TOWN OF SURFSIDE PLANNING AND ZONING BOARD AGENDA JANUARY 31, 2013 7:00 PM

То:	Design Review Board	
Thru:	Roger M. Carlton, Town Manager	
From:	Sarah Sinatra Gould, AICP, Town Planner	
CC:	Linda Miller, Interim Town Attorney	
Date:	January 31, 2013	
Re:	9560 Harding Avenue

To:	Design Review Board
Thru:	Roger M. Carlton, Town Manager
From:	Sarah Sinatra Gould, AICP, Town Planner
CC:	Linda Miller, Interim Town Attorney
Date:	January 31, 2013
Re:	9448 Harding Avenue

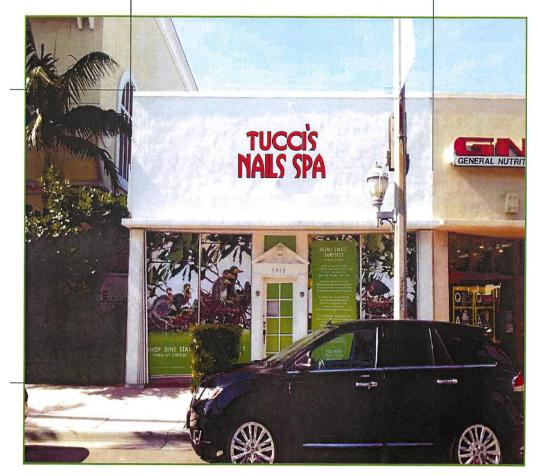
Signs	Permitted	Proposed
Area	26 square feet	25 square feet
Approved word content	Signs may include the following: 1) Trade name of establishment 2) Nature of business, services rendered or products sold on premises.	Name of establishment "Tucci's Nail Spa"
Location	With the exception of theater marquees and V-box signs, no sign shall be erected so that any portion thereof shall project over a dedicated street or sidewalk or so that any portion thereof shall project more than five feet from any main building wall.	Sign does not project over the sidewalk or street.

Staff recommends approval of the application with the following condition of approval:

1. The applicant shall follow all permit procedure as outlined in the Florida Building Code Section 105.1. A violation of this procedure shall result in a stop work order and potential code violations.
